# CO-OP MINING CO.

## SCALEHOUSE MODIFICATION

Pocket # 84-040  
Cause # ACT/015/025

RE: Scalehouse Modification  
Final Approval  
Bear Creek Canyon Mine  
ACT/015/025  
Folder Nos. 3, 4 and 7  
Emery County, Utah

FIGURE  
NO. 1

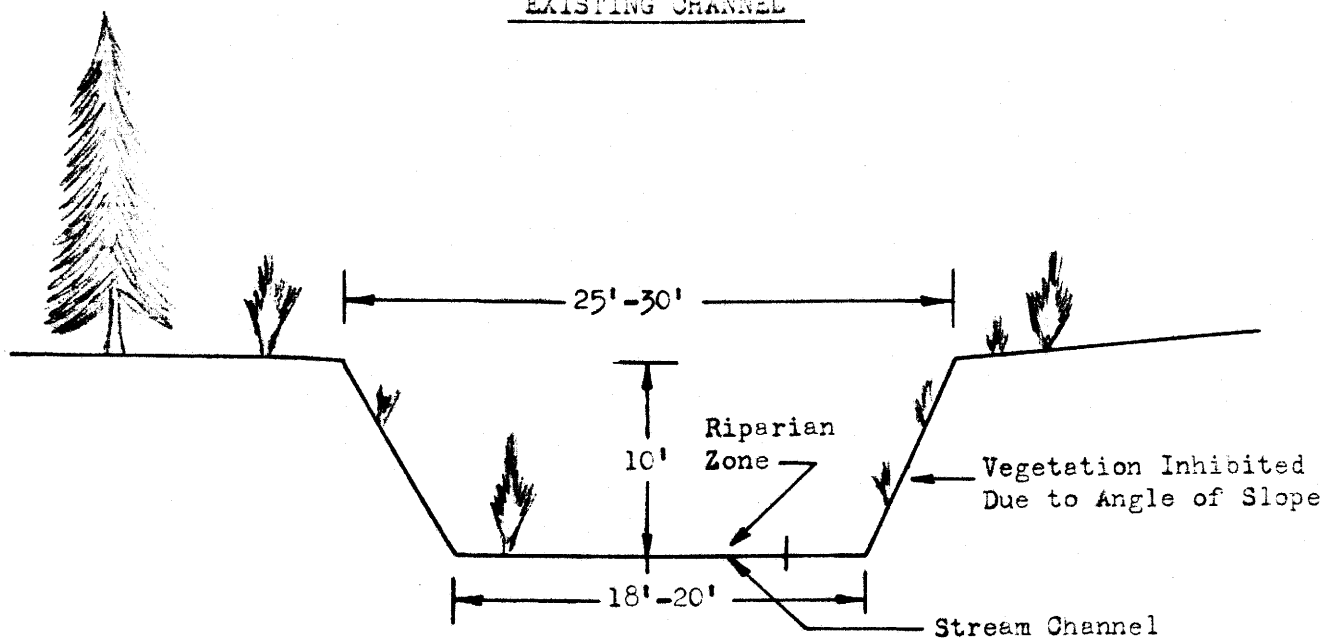
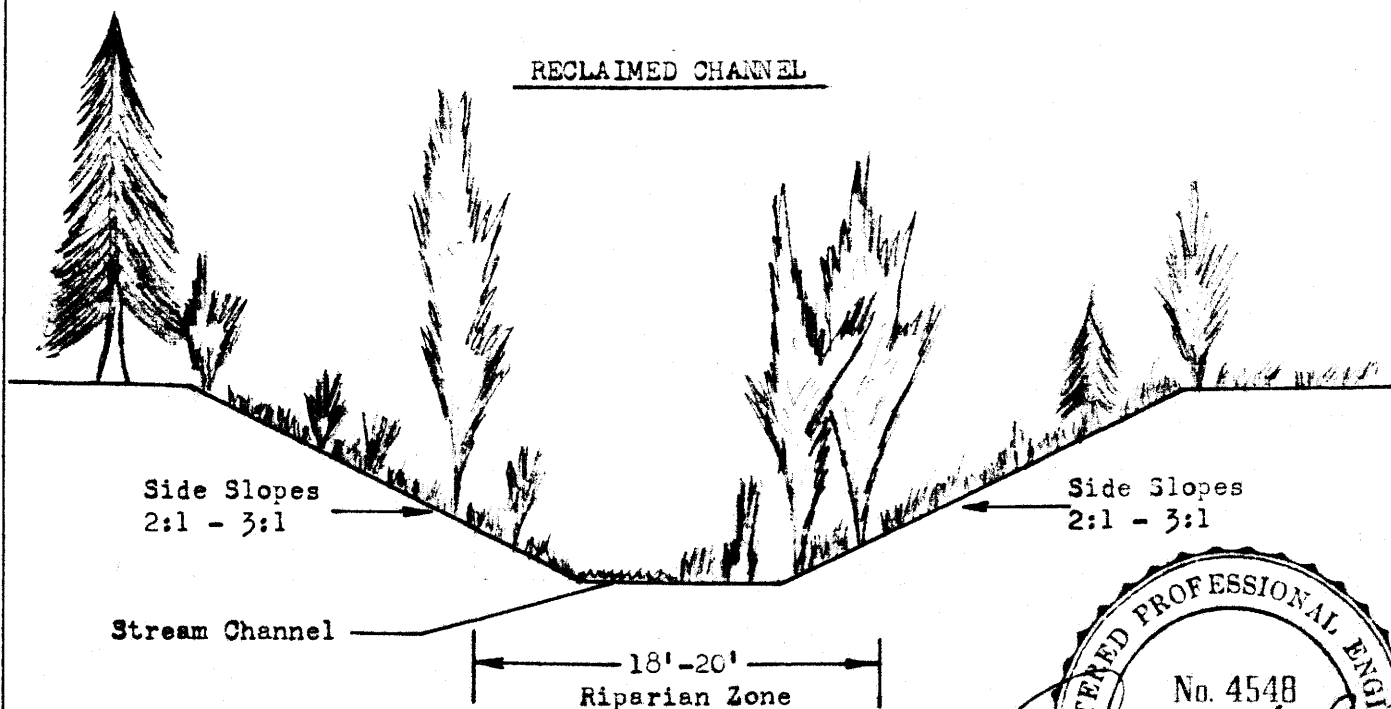
The applicant has not completely addressed this requirement. The applicant has not provided maps, plans and cross-sections to depict postmining drainage patterns. Clarification of a statement in the MRP regarding "horizontal drainage patterns," a postmining drainage map, cross-sections depicting postmining topography and drainage, specific measures for stabilizing reclaimed drainage channels and details on measures proposed for reclamation of the main stream channel where it is currently culverted were not submitted as required. The previous MRP had proposed a log check dam configuration for reclaiming the Bear Canyon stream channel. This proposal was removed by the April 30, 1984 response and the only inference to reclaiming the stream channel is the depiction of eight-inch riprap shown on Plate 3-2.

That portion of Bear Creek which is presently culverted is to be reclaimed as stated in the Approved Scale House Modification October 12, 1983. For convenience a copy of that approved plan is attached herein with the addition of the Engineering Certification as requested on May 11, 1984.

1. To use a large track mounted excavator in conjunction with a small backhoe and crawler tractor to remove the 60' culvert and to regrade the opposing banks on approximately a 3 to 1 slope to facilitate revegetation and to enhance the establishment of a riparian zone. (Note fig. 1 for the present stream configuration and projected after reclamation).

FIGURE  
NO. 2

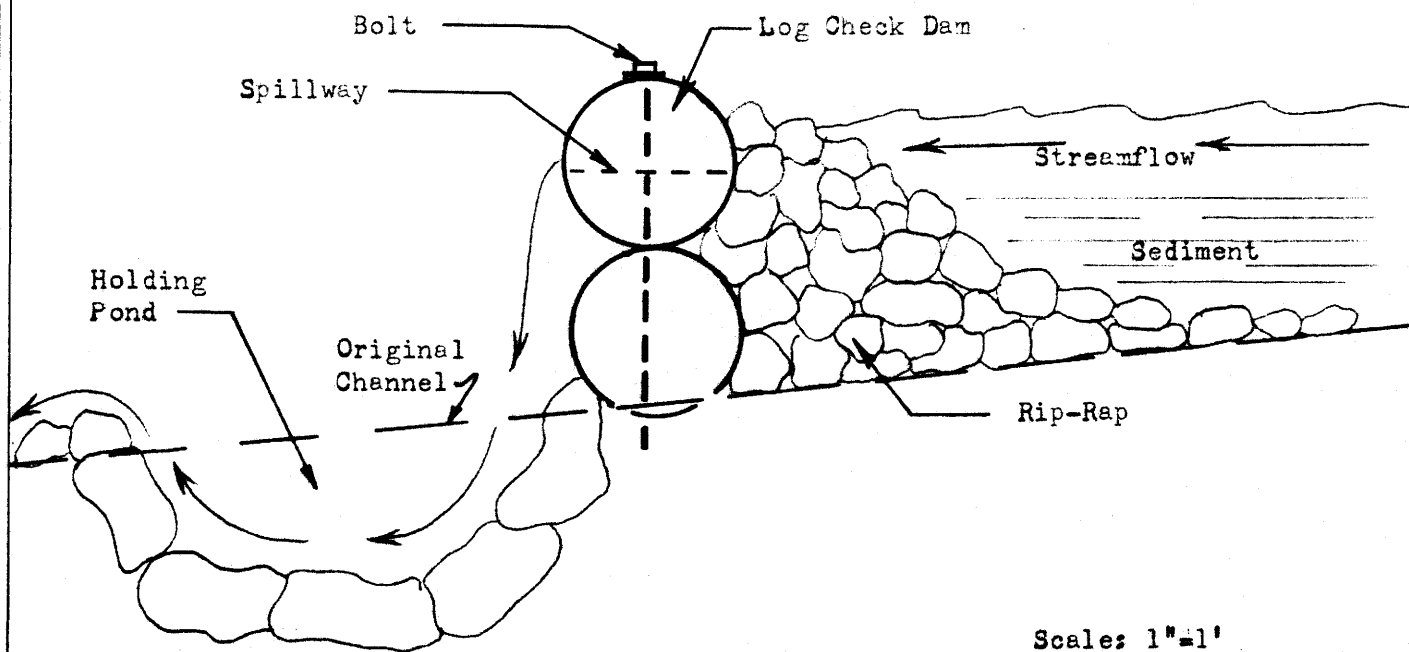
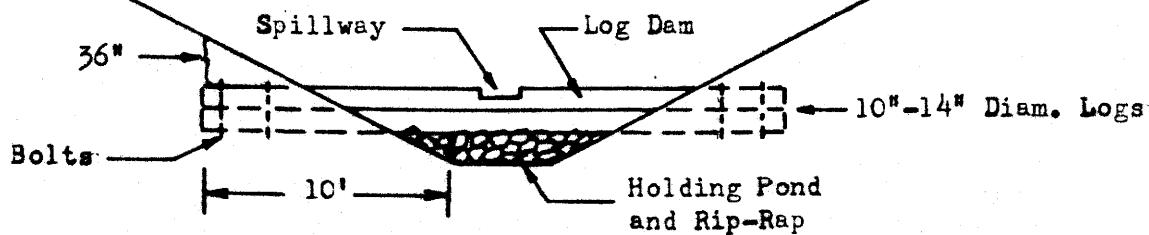
MODIFICATION DEFICIENCIES

LOG CHECK DAM AND HOLDING POND
